RECALL CAMPAIGN
INSTRUCTIONS

REF. NO. 60
TAKATA PASSENGER FRONTAL
AIR BAG MODULE

458
ITALIA

Ferrari
California

Fig. 1

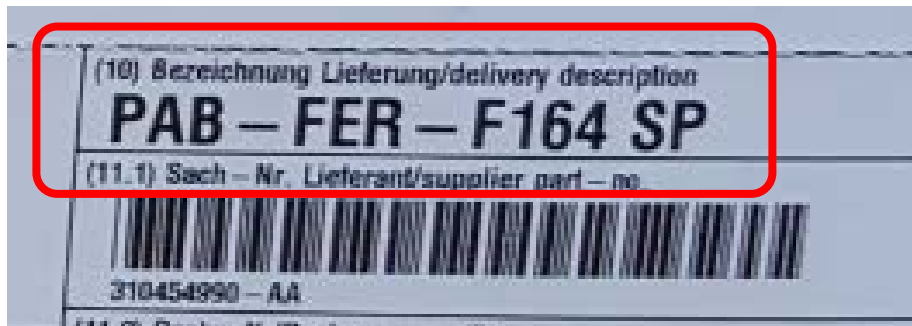
- 1.1 Remove the label with the airbag identification details, shown in Fig. 1, from the new airbag and affix it in the relative space in a printout of the “Passenger side airbag module replacement traceability form”, included in this booklet.

The new component is marked with a specific label bearing the phrase "PAB-FER-F164 SP" on the packaging, as seen in Fig. 1.

- 1.4 The installation of the new airbag module **P/N 70004993** requires the use of a special bracket to mount the airbag to the dashboard. See the Overview section of this booklet for the bracket part numbers as well as the hardware part numbers.
